ADDENDUM #2

Project Name: Chancery Sump Pump Project - Beijing
Project No.: H-BEJIN-020.4.02
Solicitation No.: 21-179584
Date: November 22, 2021

Sewage design data

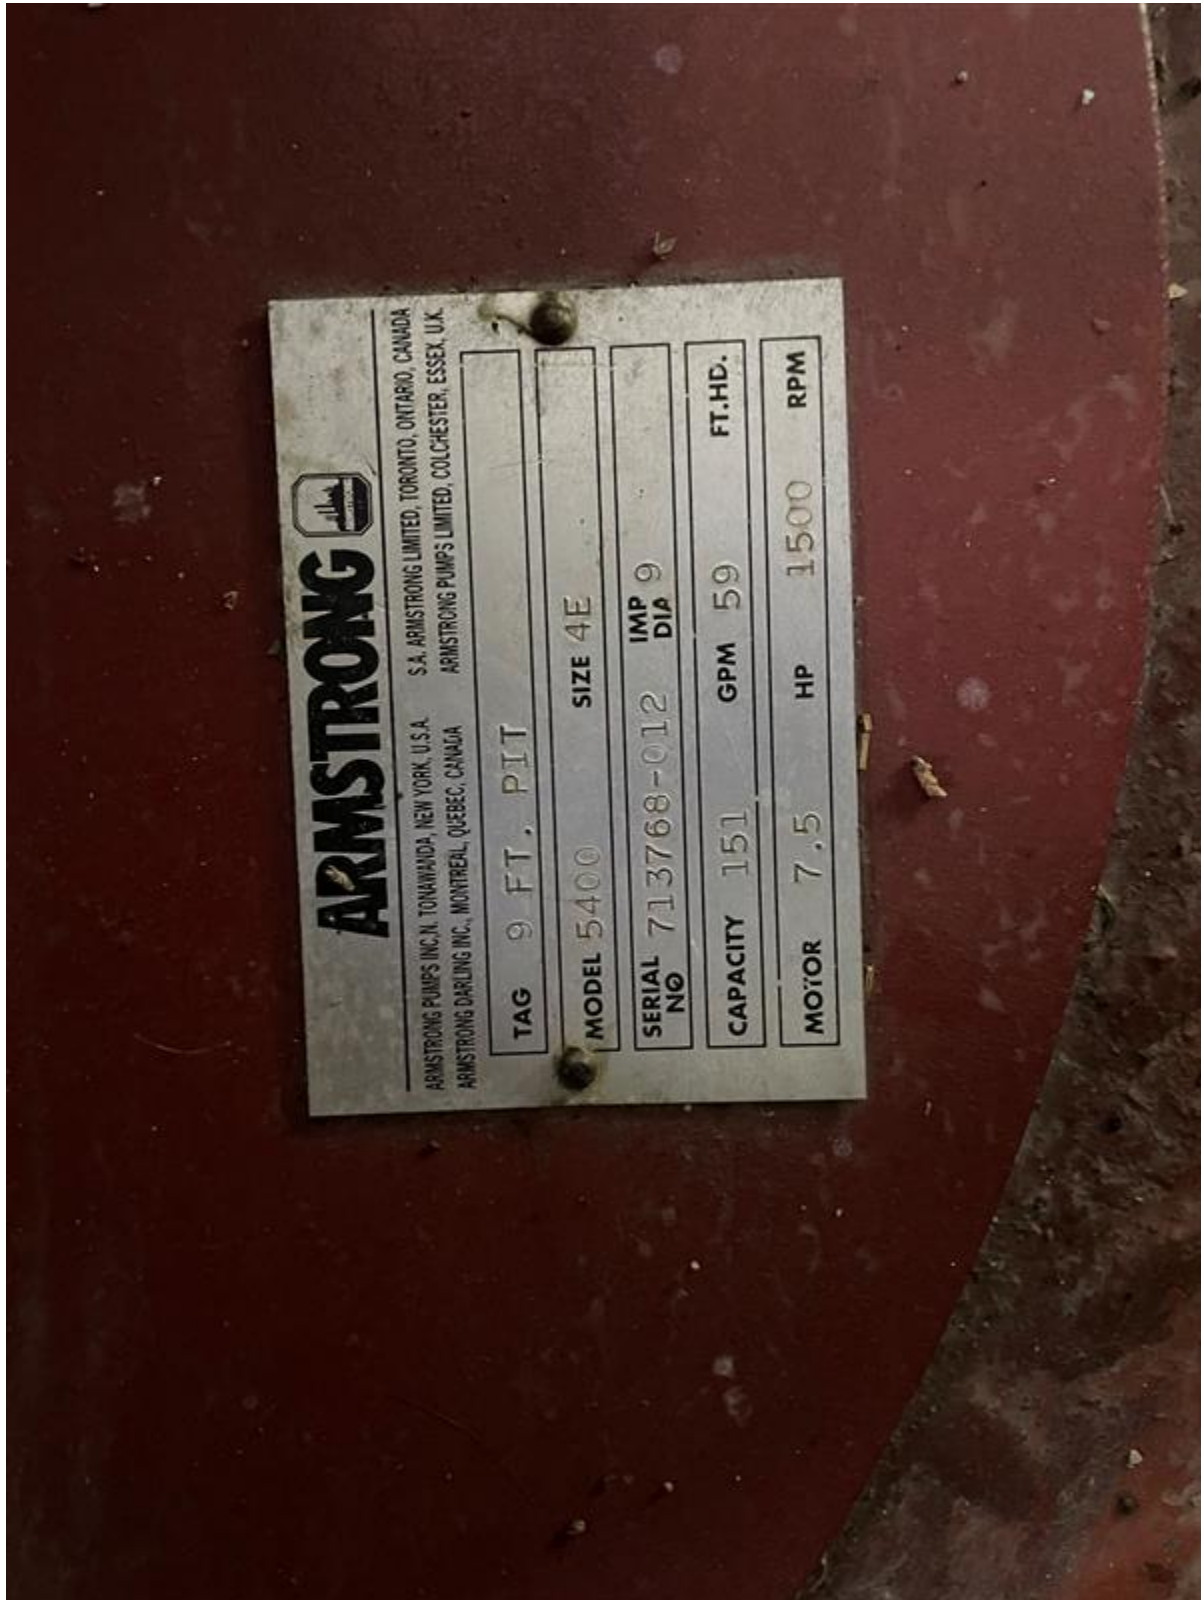
INSERT:

Inside dimensions:
Length:1200mm
Width:1200mm
Depth:3000mm

Sewage pump parameters

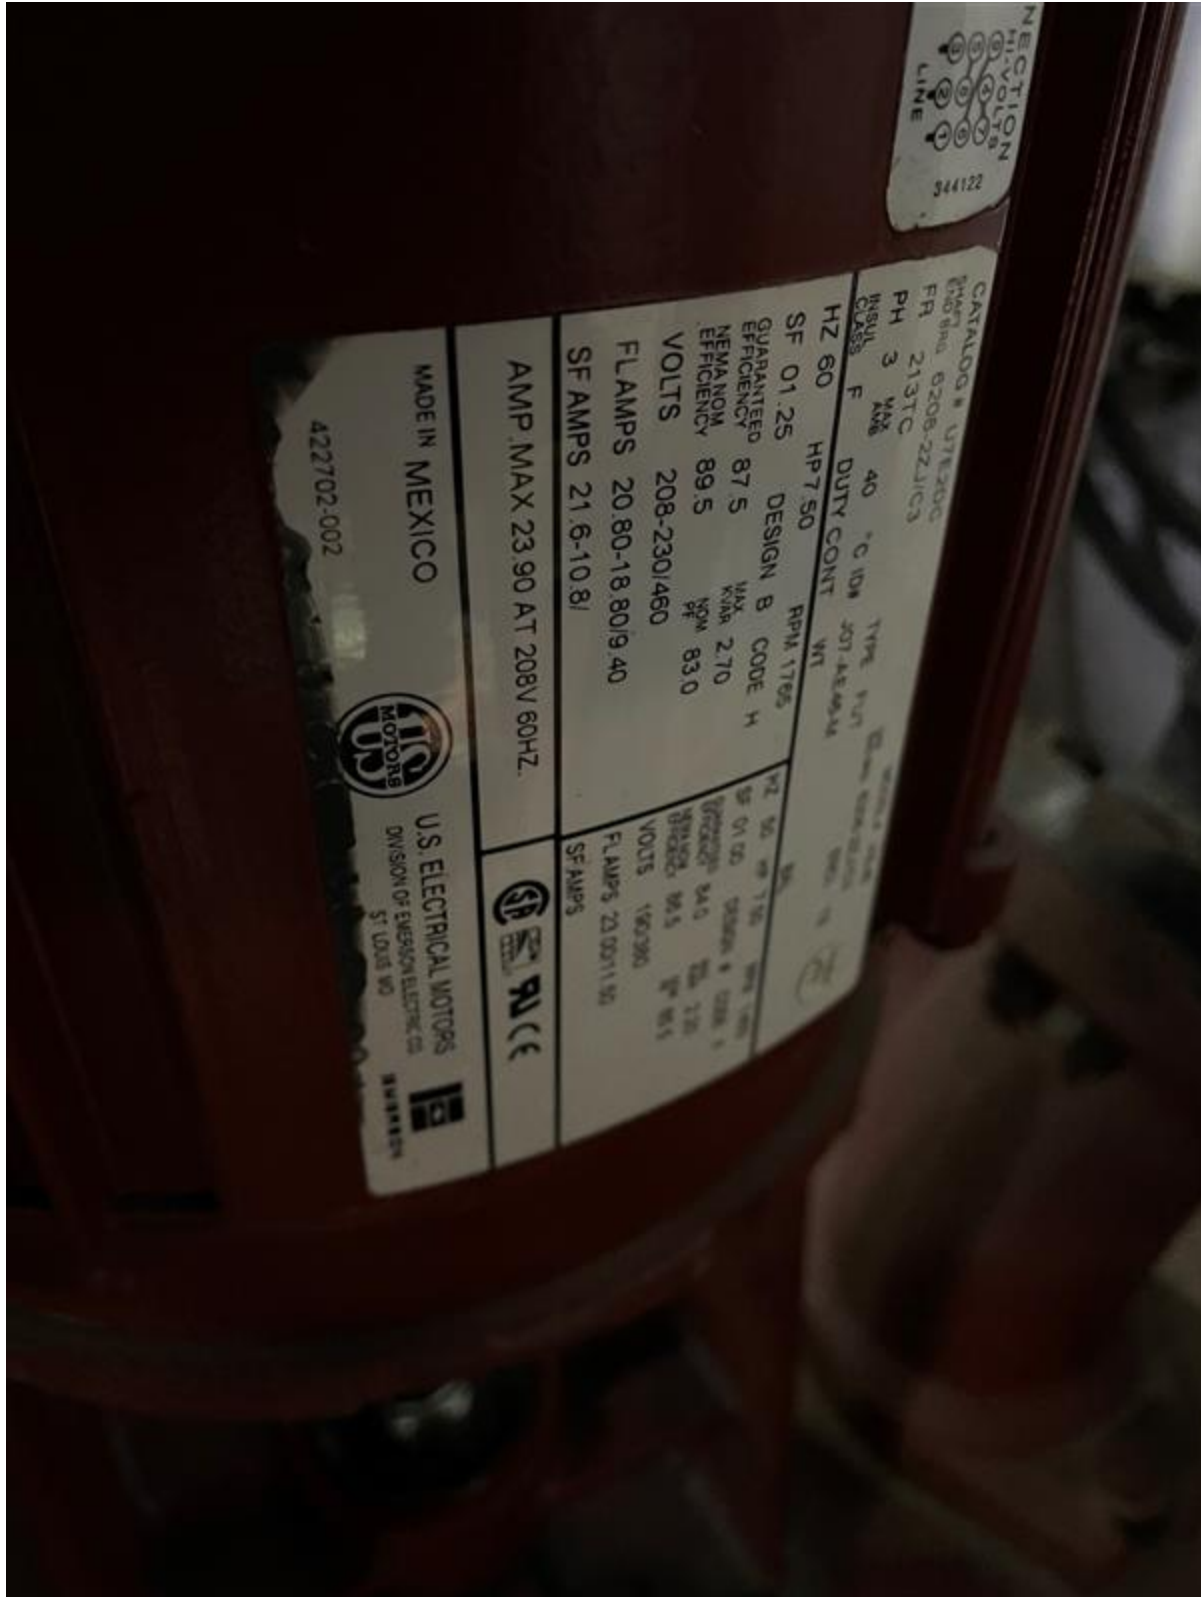
Pump brand: Armstrong
Model number: series 5400 duplex unit
Pump size:4E-3
Capacity USGPM :151(9.5 L/S)
FEET HEAD:59(18M)
